SPECIAL MAINTENANCE INSTRUCTION NO. RDSO/2006/EL/SMI/0241 (Rev.0)

- 1.0 **Title:** Provision of modified Traction Link flange mounting bolts in WAG9 and WAP7 three phase locomotives.
- 2.0 **Background:** Frequent cases of breakage/loosening of Traction Link bolts were reported from all the sheds homing WAG9/WAP7 locos. Initially locking plates were provided and property class of bolts was changed from 8.8 to 10.9. However, this has not solved the problem and the failures continue.

MODIFIED TRACTION LINK BOLT

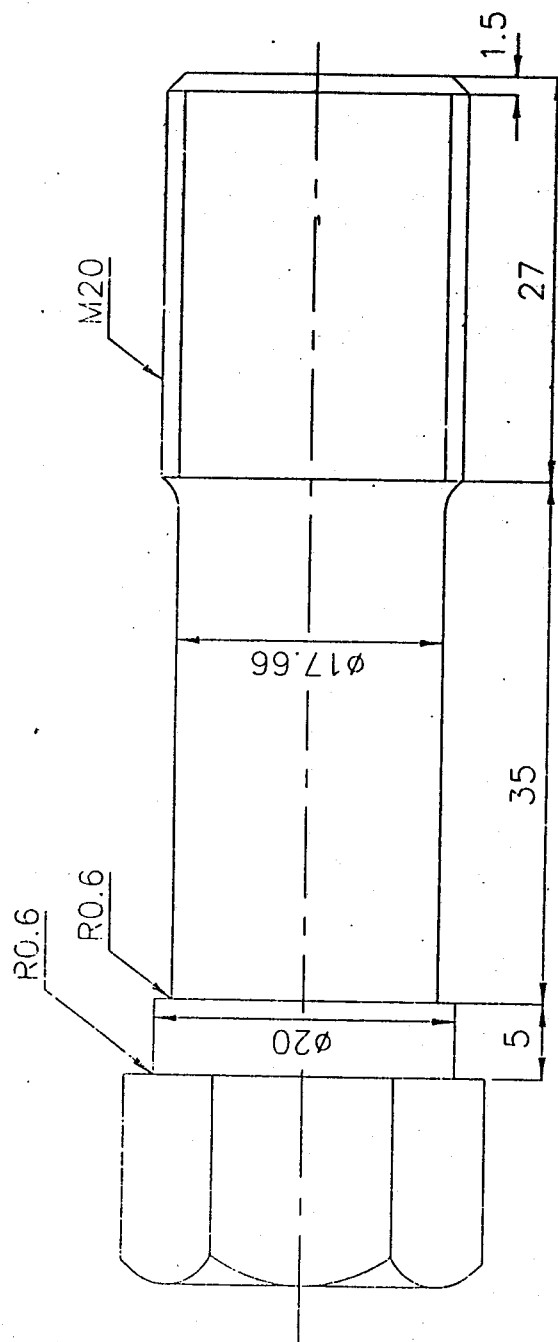
- 4.2 Increase diameter of all the six holes to 21mm on both sides of Traction Link flange as well as on both the Pivot Heads flange.
 - 4.3 Re-assemble Pivot Heads with correct alignment and mount the Traction Links. Fit the uniform strength (reduced shank) flange mounting bolts with steel self lock nuts and machined washer as per 6.0 below.

(i)	Hexagonal head uniform strength (reduced shank) M20 bolt of property class 8.8 to IS: 1367 part (3) to dimensions as per attached drawing. 24 nos. / loco.	The hardware should be procured only from Part-I sources of such items in the CLV's approved list of sources for 3 phase loco.
(ii)	Hexagonal Steel Self Lock Nut to suit above bolt. 24 nos. / loco.	
(iii)	Machined washer of size 21mm to IS: 2016. 48 nos. / loco.

- 4.4 Tighten the above bolts with nuts by appropriate torque wrench to 260 Nm.
 - 4.5 Self lock nuts should not be reused, otherwise positive locking will be lost.
